**PD Modification Application:
MM 23-0520**

Zoning Hearing Master Date: 10/16/23

**Hillsborough
County Florida**

Development Services Department

PD-1

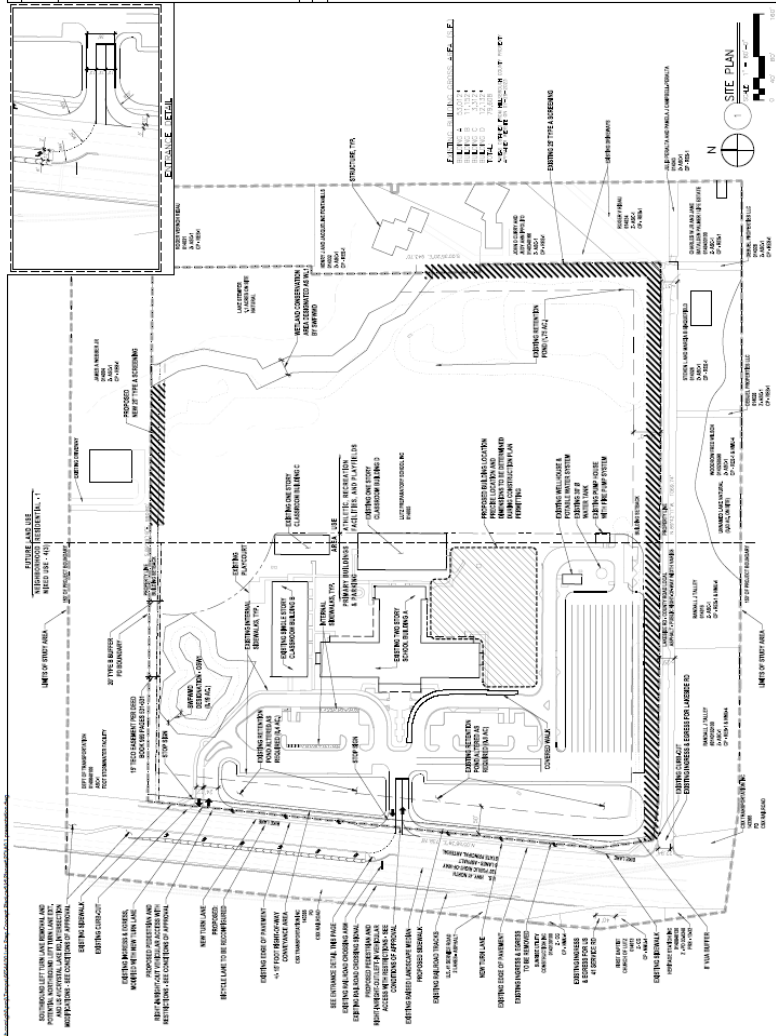
- Incorporate sheet PD-3 from the 5/11/23 submittal into the certified plan set; and,
- Modify the Site Plan (Sheet PD-1) to revise the "Proposed Use" portion of the site data table. As currently shown the table indicates a maximum of 1,102 students are possible within the school, which is inaccurate. Specifically, table must be revised to accurately describe the combined maximum enrollment, and individual minimum and maximum enrollments for each use, consistent with the proposed revisions to condition 2, hereinabove.

which is inaccurate. Specifically, table must be revised to accurately describe the combined maximum enrollment, and individual minimum and maximum enrollments for each use, consistent with the proposed revisions to condition 2, hereinabove.
